WestConnex Stage 3 – Pre-Opening Performance Plan.

This document provides the City of Sydney ('the City') submission on Transport for NSW ('TfNSW') *WestConnex Stage 3 Road Network Performance Plan – September 2023* ("Draft Stage 3 Pre-Opening Plan").

Trends in travel to the Sydney City Centre - AM peak 1 hour

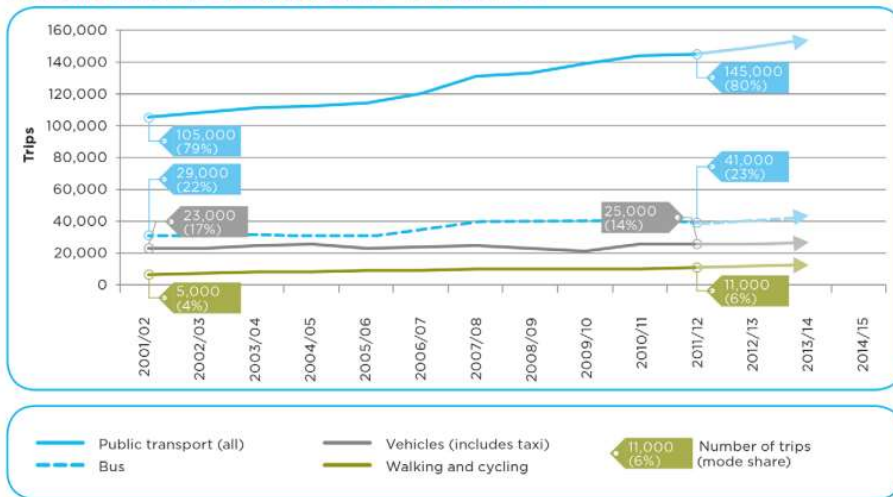
TfNSW continues to argue that they need to *provide* for increased in vehicle traffic accessing the Sydney City Centre and Pymont because of the planned development in these precincts – because that is what their Strategic Model *predicts*. Traffic models should assume zero background vehicle growth in the City of Sydney LGA.

The NSW Government's *Sydney City Centre Access Strategy* showed that between 2001 and 2014 (a period of unsurpassed development), the number of vehicles accessing the City Centre plateaued, with growth in travel demand being served by public transport, walking and cycling.

Since George Street was closed for light rail, TfNSW reports that driving to the City Centre has actually decreased by 15-18%. Modified working arrangements following Covid shutdowns have continued these trends of reduced driving.

TfNSW insists on keeping the modelling, and modelling inputs / outputs supporting the plan secret. This deprives taxpayers of transparency of the assumptions justifying the planned road augmentations.

Requirement: The Draft Stage 3 Pre-Opening Plan must provide the following key information supporting the modelling process and outcomes that informed the plan:

Figure 13 Investment in major transport infrastructure presents opportunities to reduce traffic speed and reallocate road space for walking and cycling

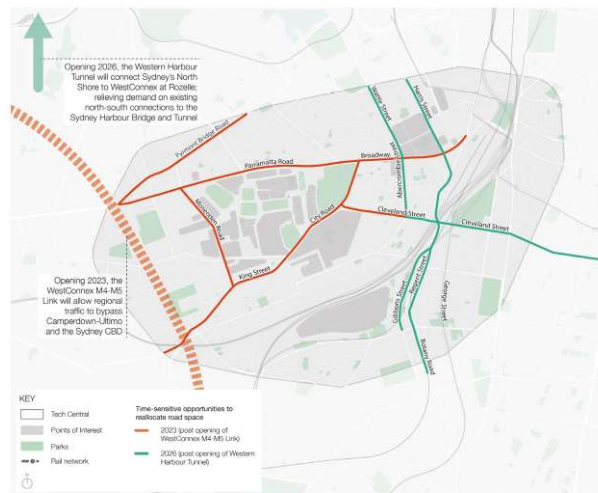
TfNSW Tech Central Place-based Transport Strategy identifies improvements to walking and place on Broadway as a time sensitive road space reallocation opportunity. WestConnex public collateral materials reinforce this reallocation, stating traffic volumes on Broadway will drop by 50%.

The Draft Stage 3 Pre-opening Plan Mitigation measures fail to identify Broadway as part of their suit of measures, ignoring TfNSW own planning framework. The City has worked with TfNSW to develop a proposal.

TfNSW should provide funding for reallocation of road space on Broadway firstly, to implement a tactical solution and secondly, the permanent solution. This Mitigation measure should be part of the suit of mitigation measures discussed on page 9.

Requirement: The Draft Stage 3 Pre-Opening Plan must include improvements for place, walking and cycling on Broadway
